Addendum #2

VA Project No.: 553-21-100

Project: Renovate A2 South for Cancer Clinic
John D. Dingell VA Medical Center
Detroit, Michigan

Date: May 1, 2026

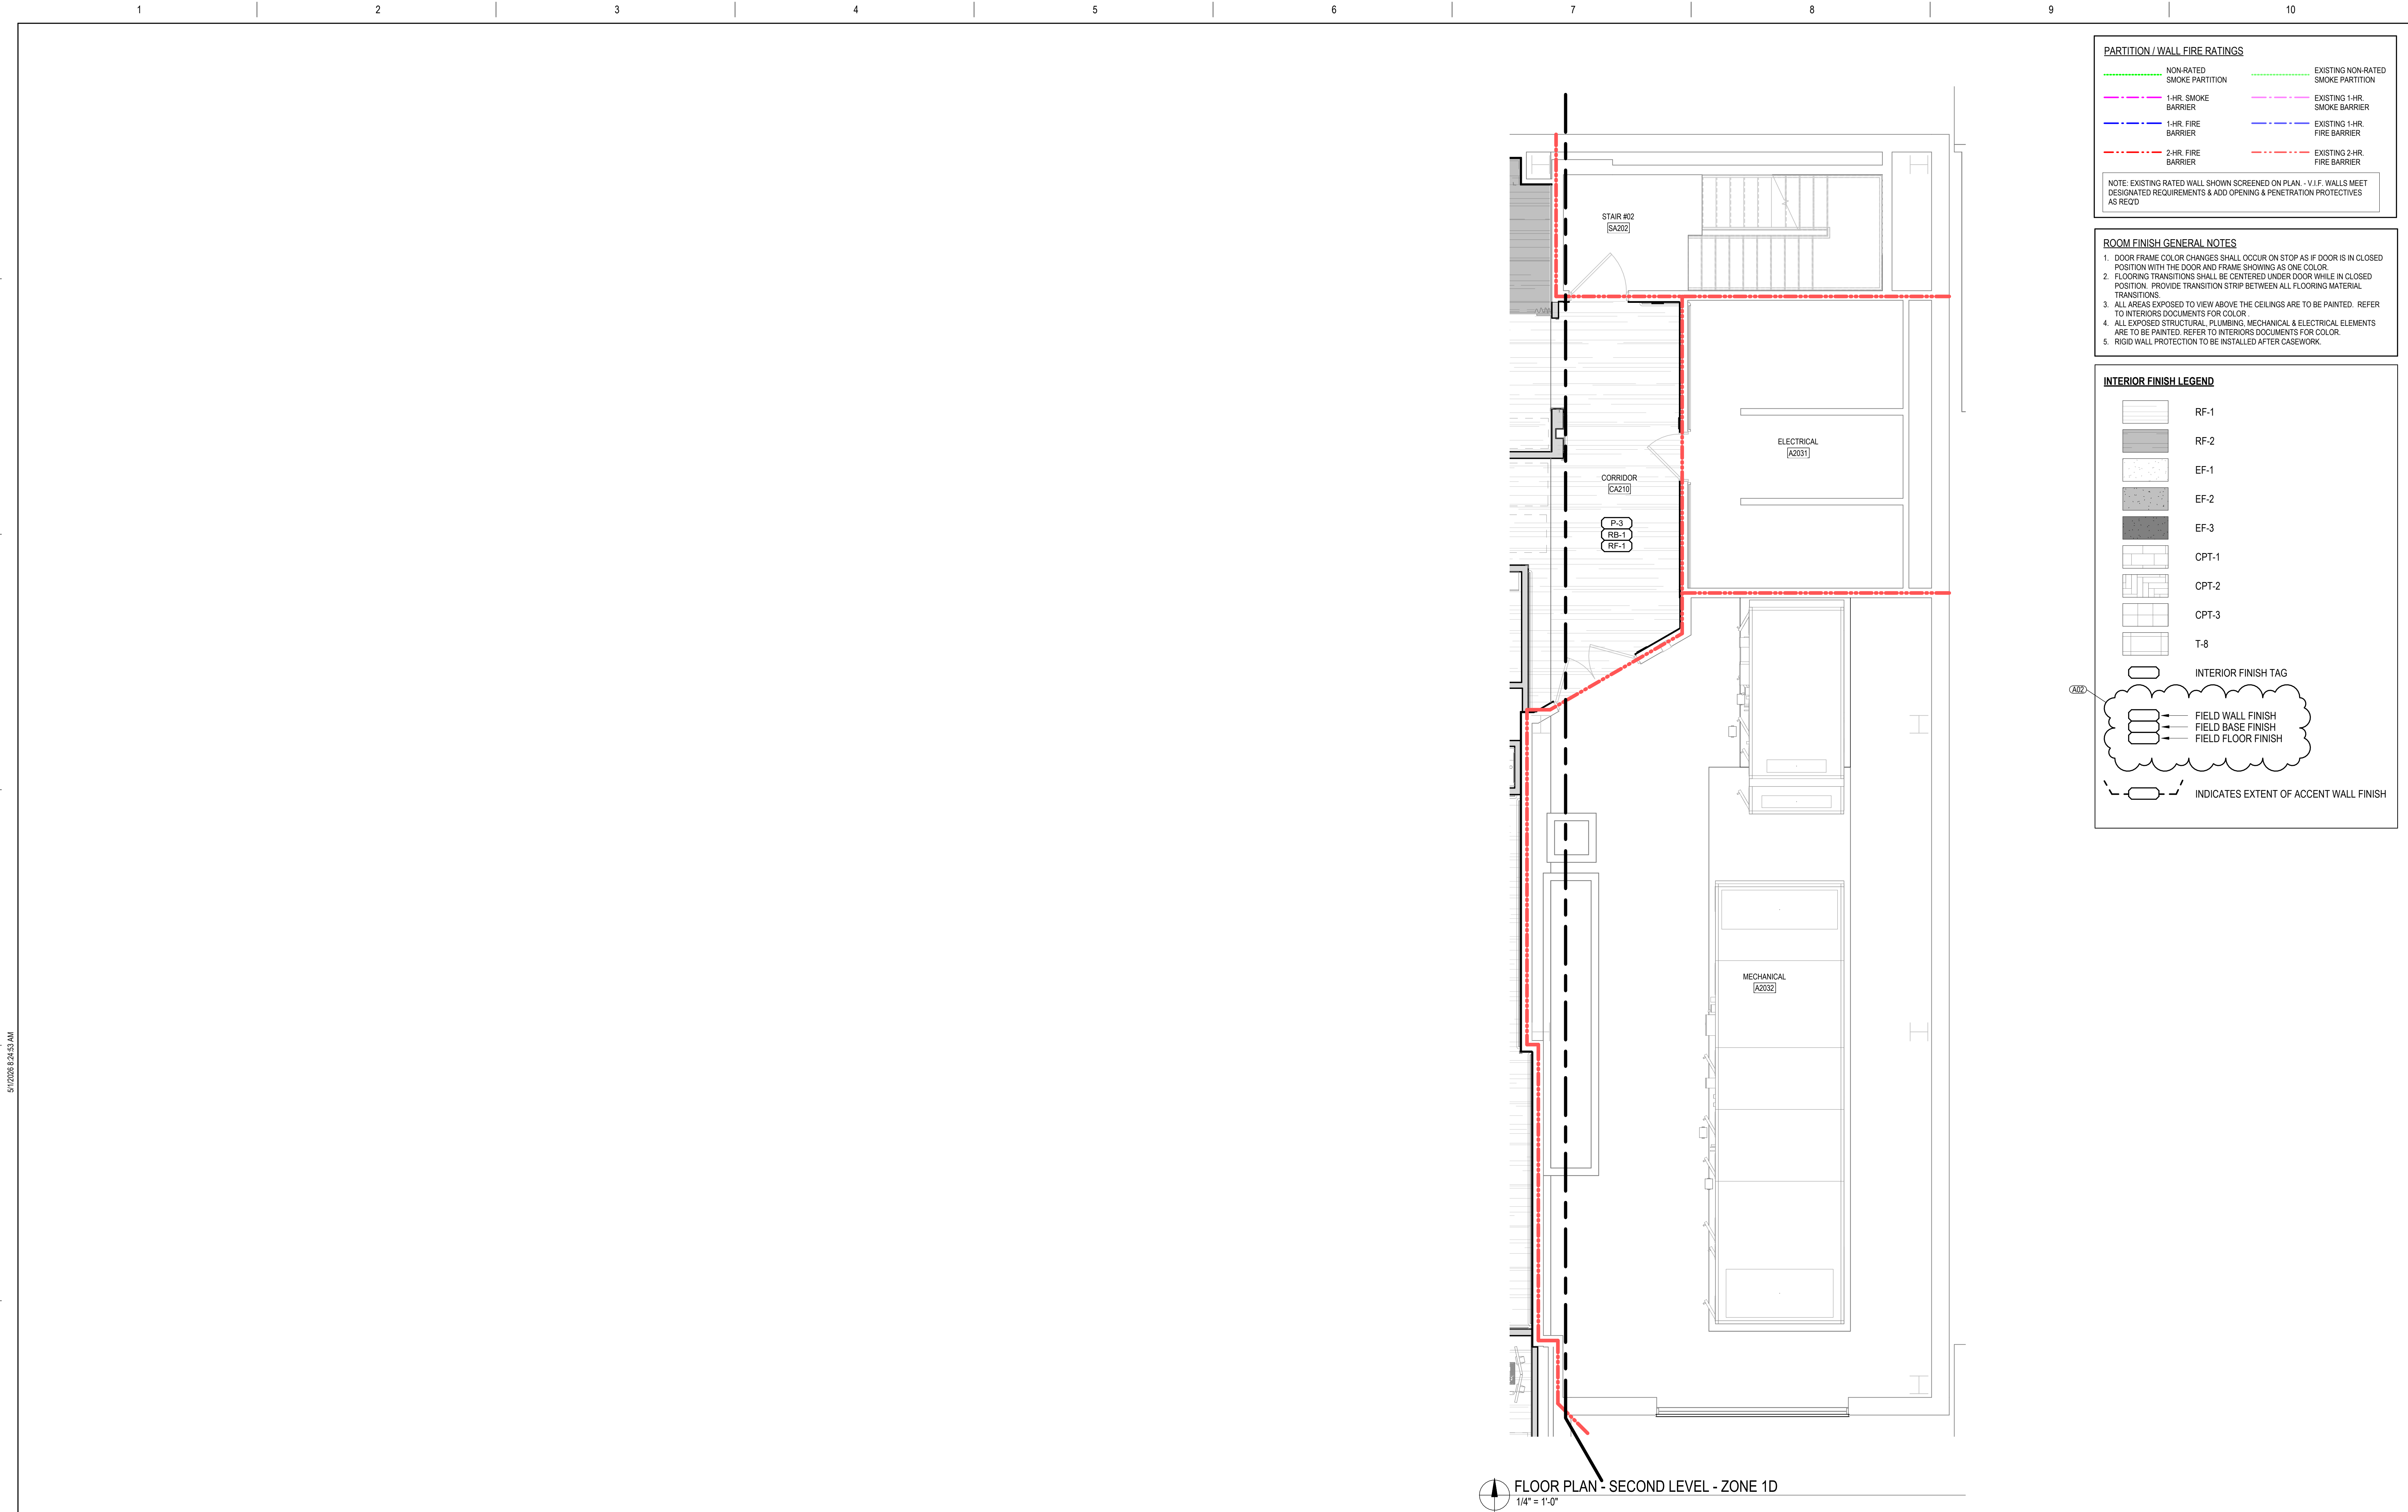
a. Revise length of wall protection.
b. Add keynotes for accent flooring.
c. Revise demarcation line notes.
- A2.14 Refer to Sheet I-120 (reissued):
Revise signage

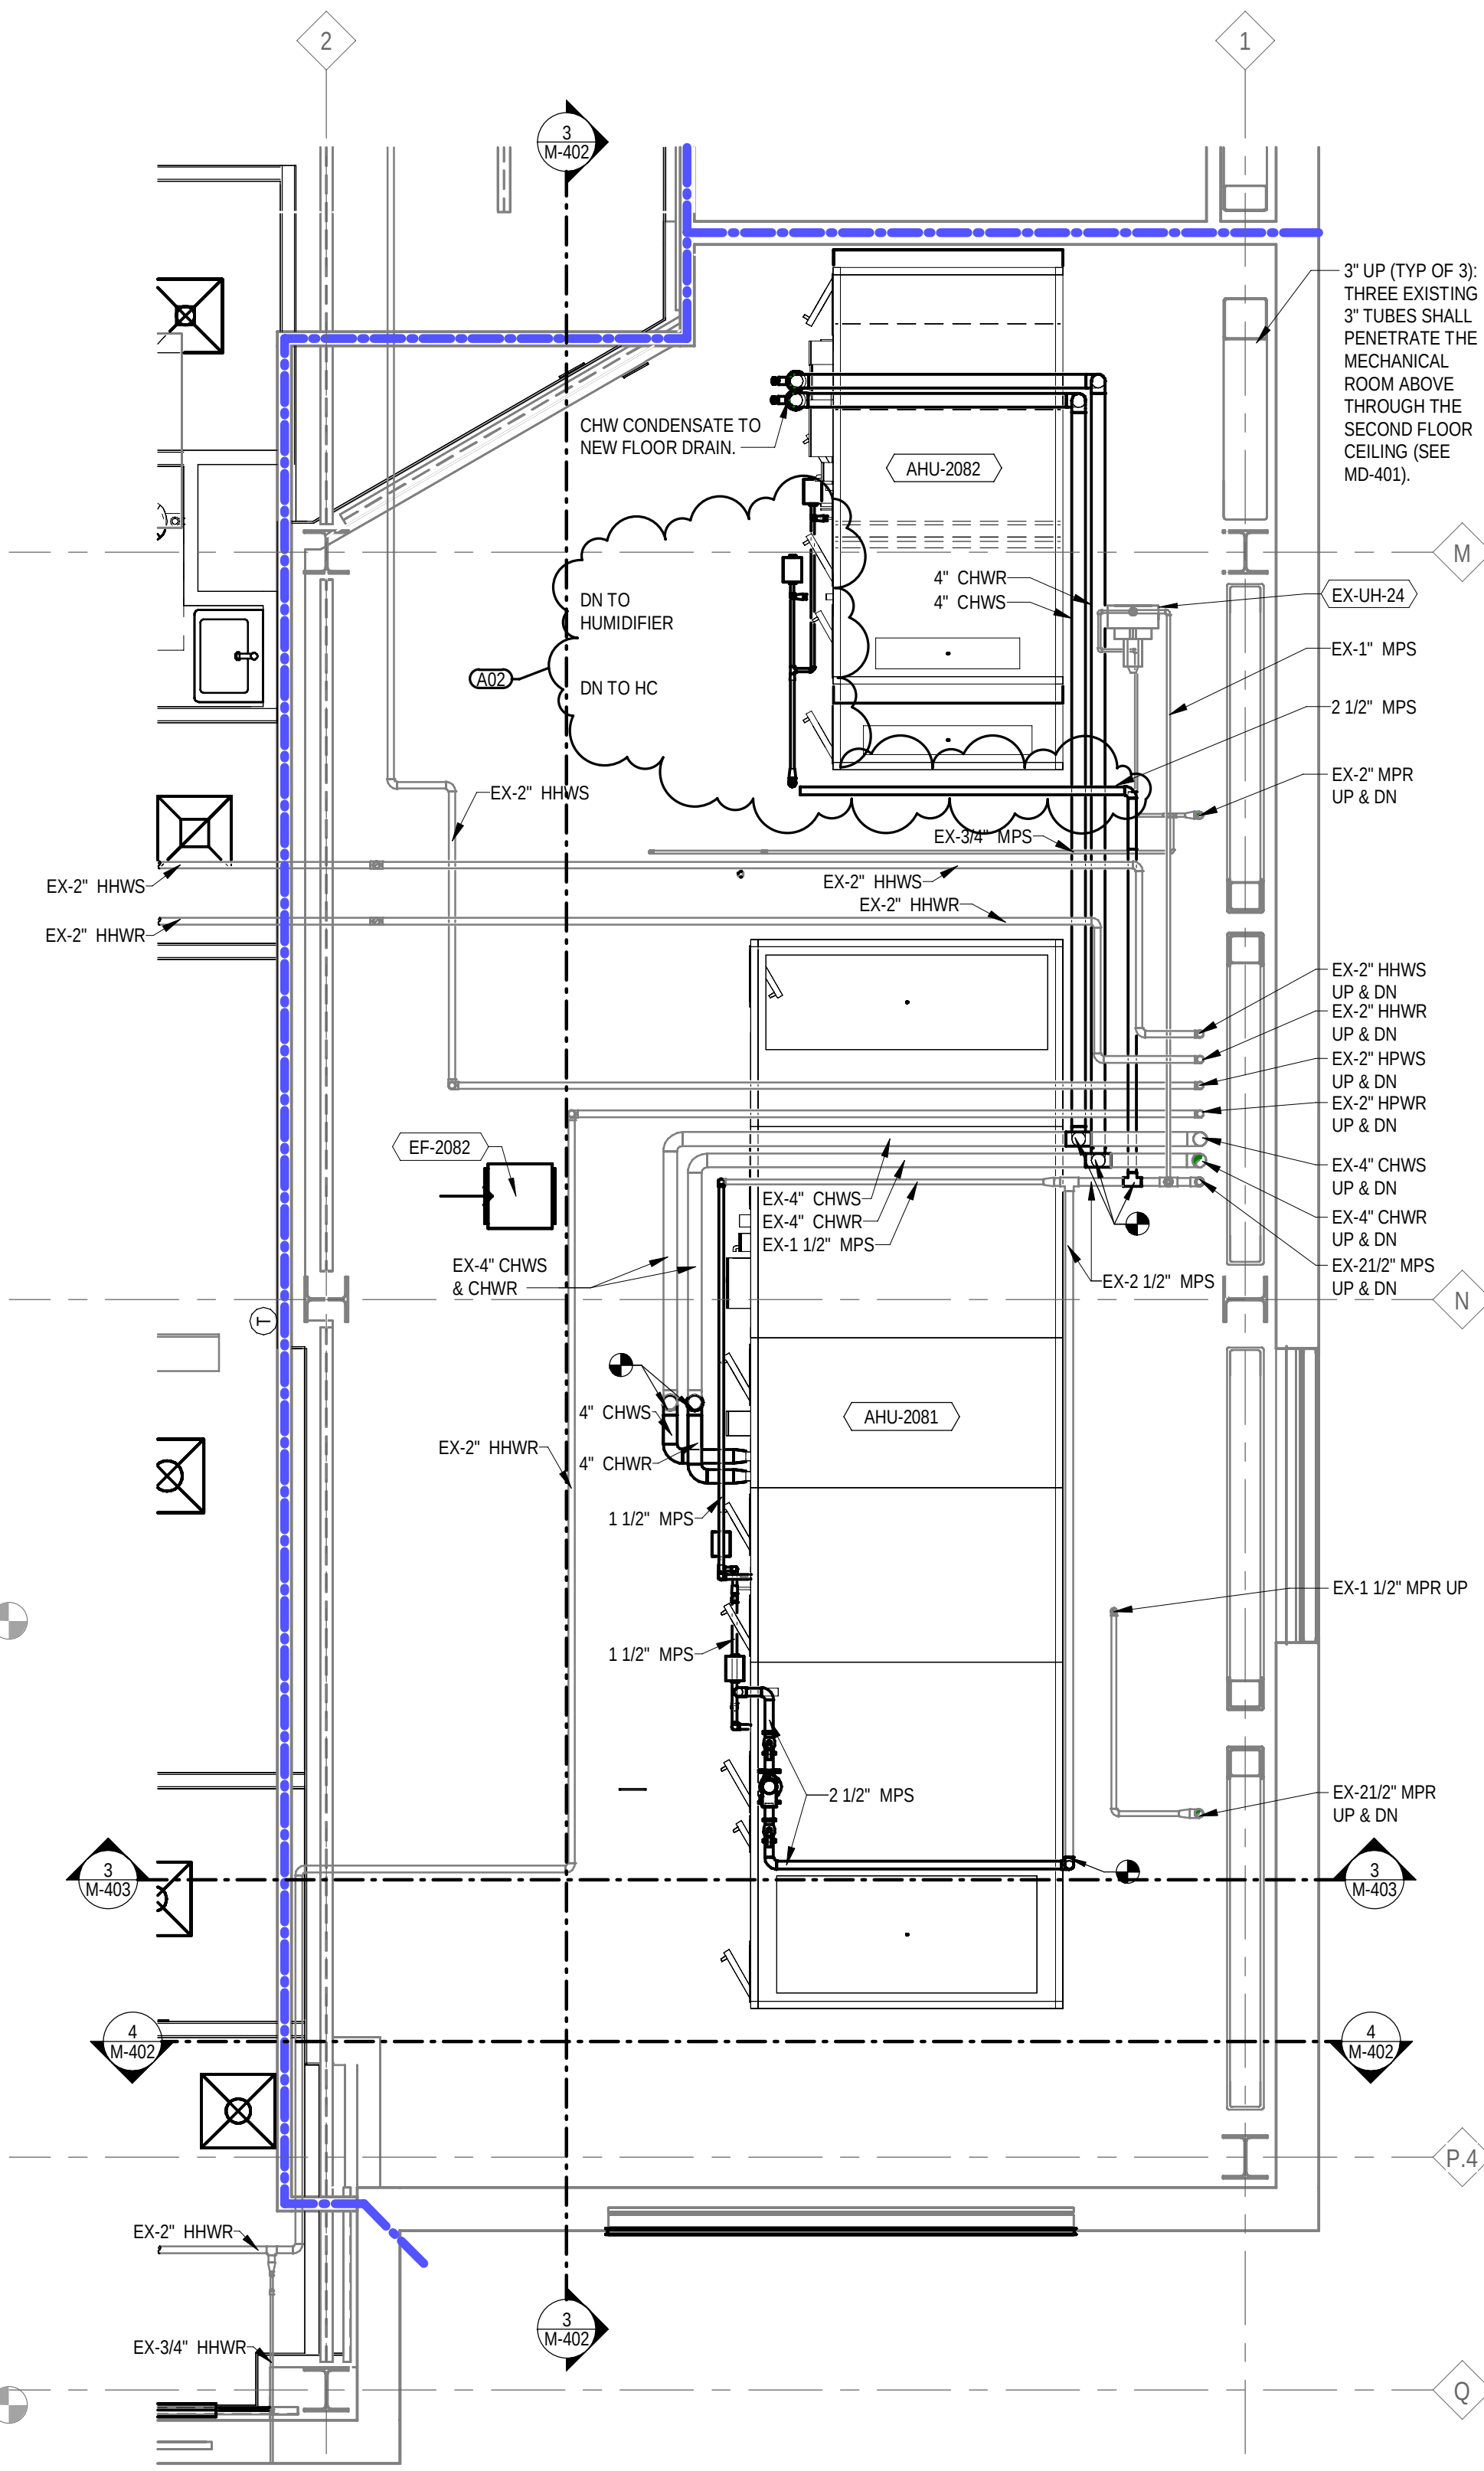
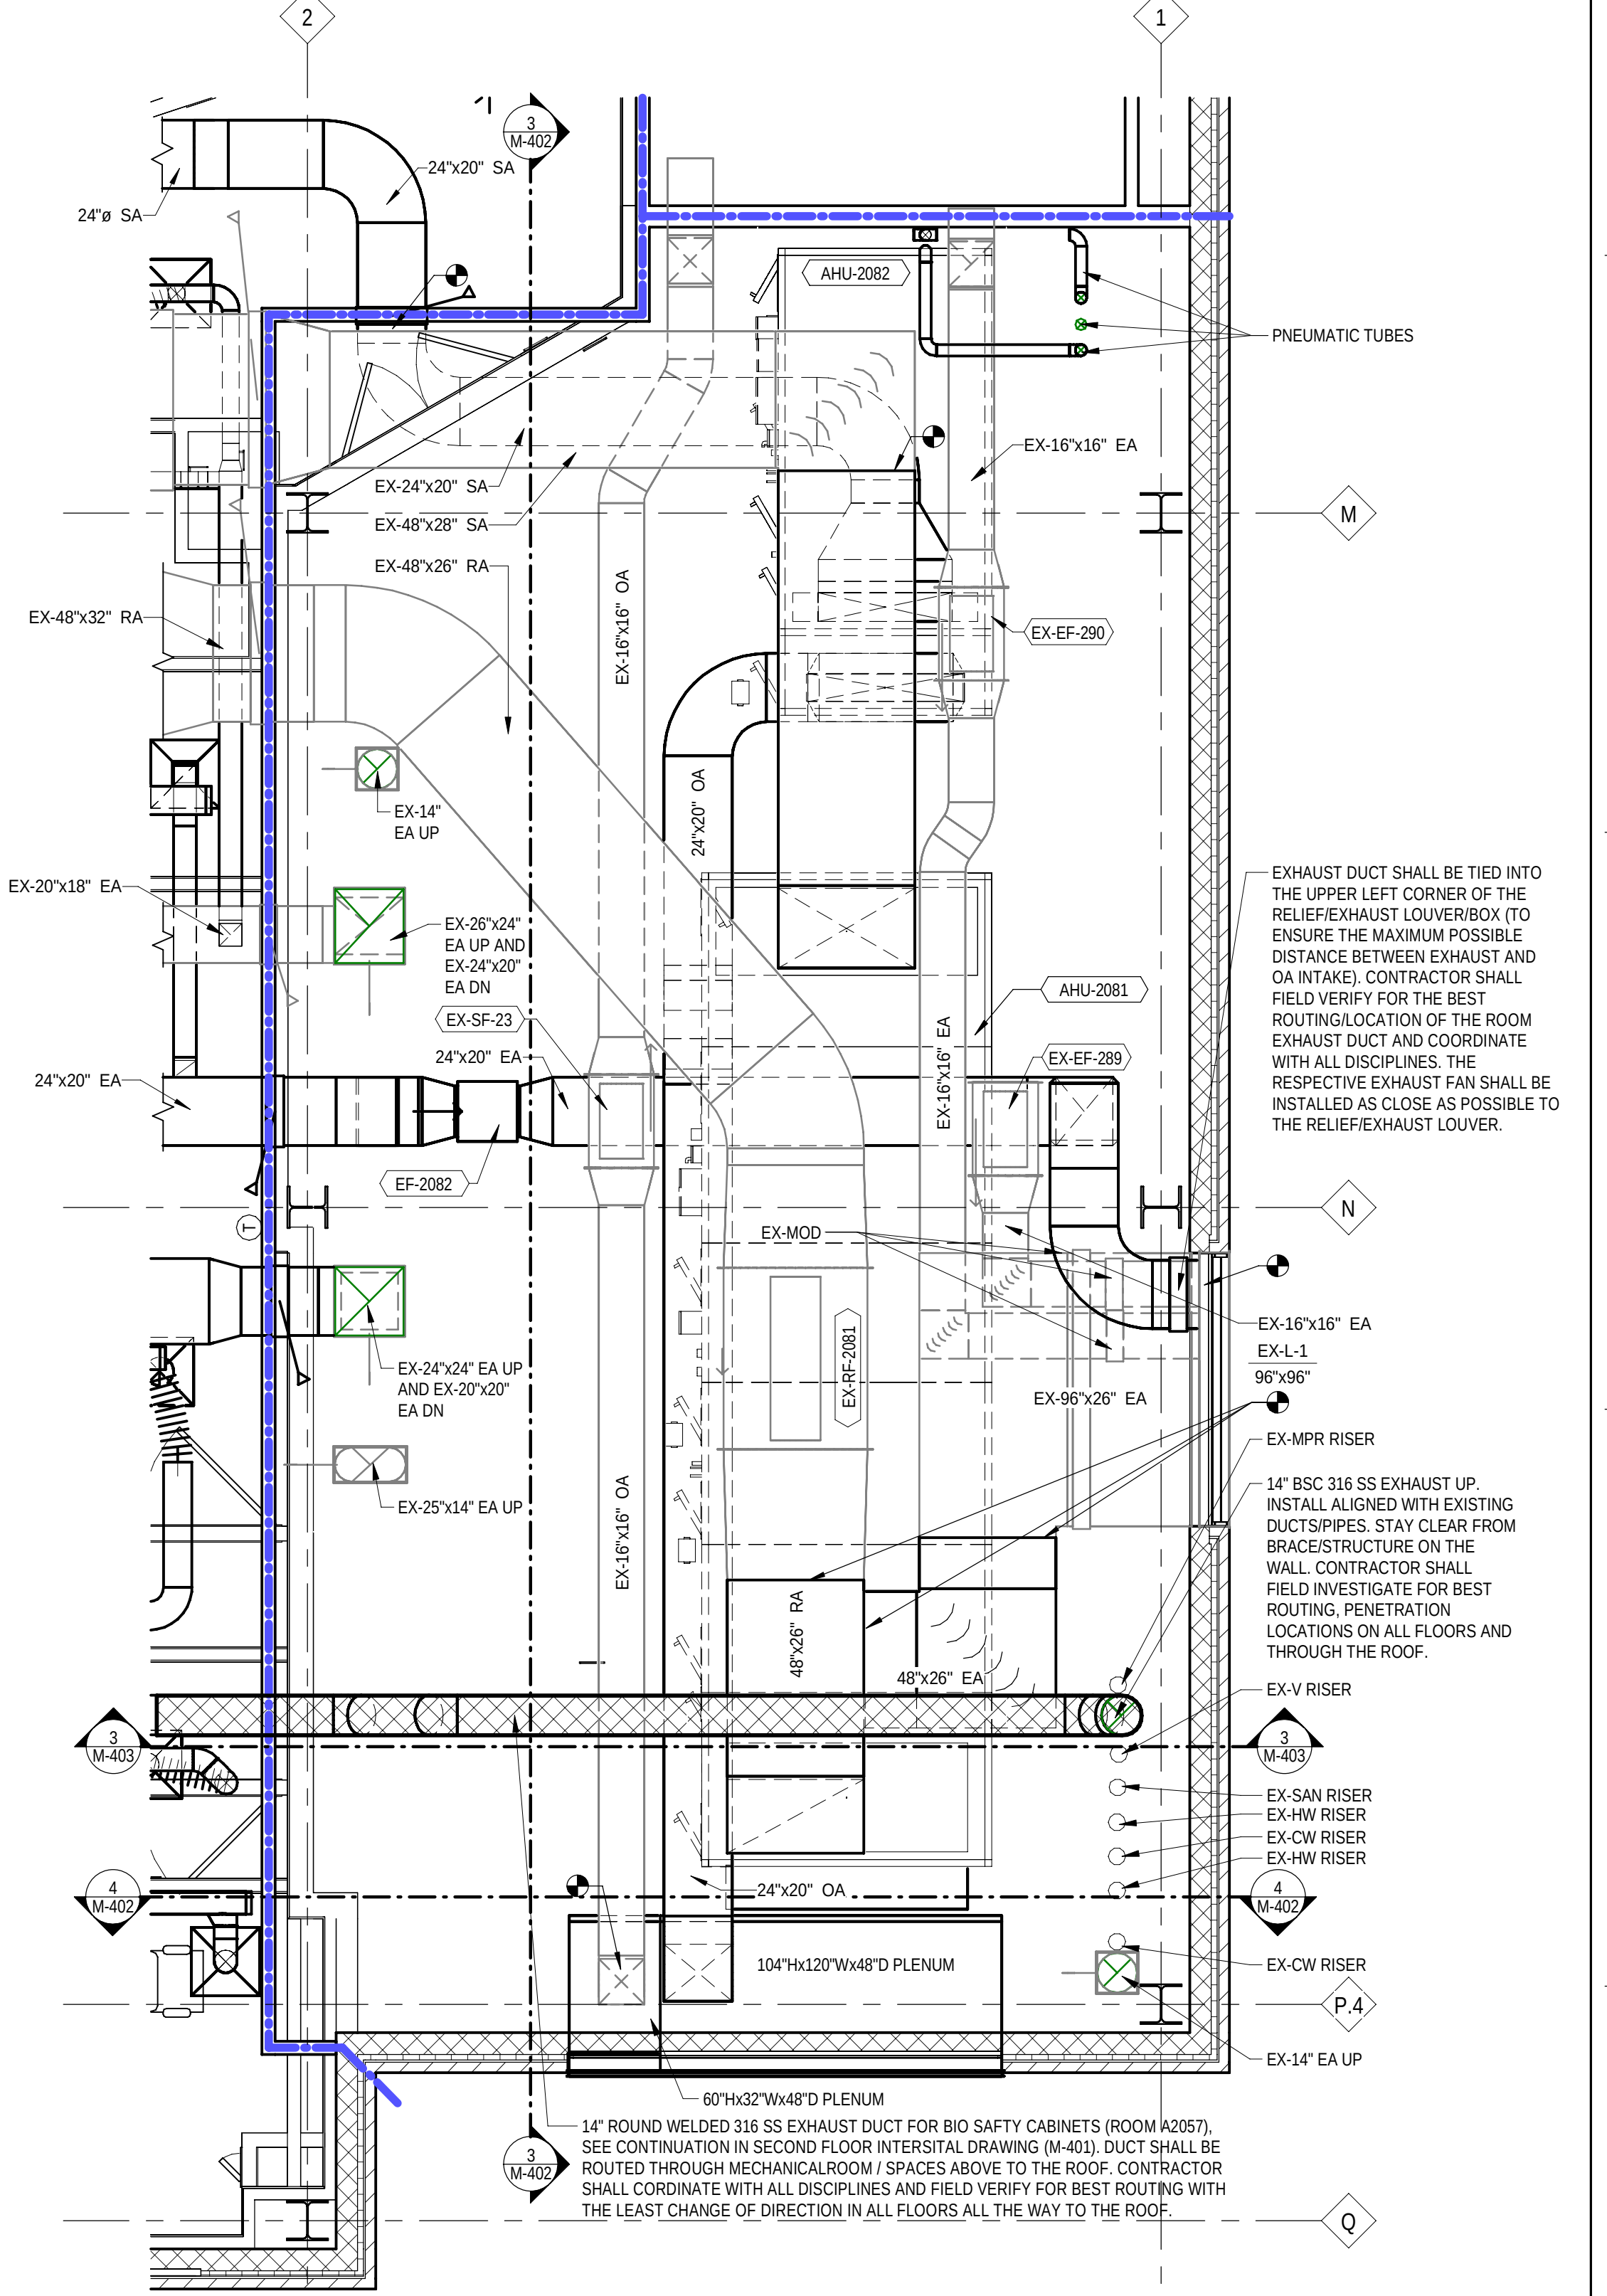
- A2.17 Refer to Sheet M-402 (reissued):
Revise AHU-2082, the MPS (medium pressure steam) and MPR pipe routings to/from the steam humidifier and steam heating coil (HC) on "ENLARGED MECHANICAL ROOM A2032 PIPING PLAN" and "SECTION - MECHANICAL ROOM A2032".
